UNITED STATES  
DEPARTMENT OF THE INTERIOR  
BUREAU OF LAND MANAGEMENTFORM APPROVED  
OMB NO. 1004-0135  
Expires: July 31, 2010**SUNDRY NOTICES AND REPORTS ON WELLS**  
*Do not use this form for proposals to drill or to re-enter an abandoned well. Use form 3160-3 (APD) for such proposals.***SUBMIT IN TRIPLICATE - Other instructions on reverse side.**

## BP - San Juan Wellwork Procedure

### Pritchard 6E

30-045-26149

# Proposed Wellbore Diagram

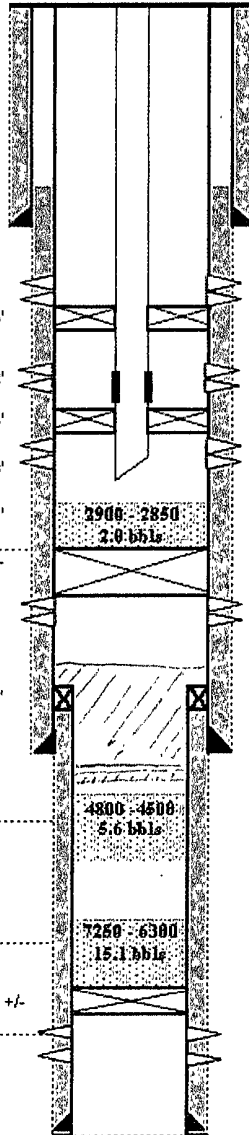
\* cannot produce new perforations without a NOI + C-104

10. Isolate Picture Cliffs by setting a CIBP above perforations and placing 50' of cement on top  
3rd Plug: 2900 - 2850 → 50' → 1.9 bbls  
**NOTE:** this will isolate the PC formation and allow us to perforate the Lower Cottonwood at 2830-2836'.  
*Thacker plug  
3677'-3577'  
4 1/2" inner tub /  
7" casing shoe  
3545' - 3286'*
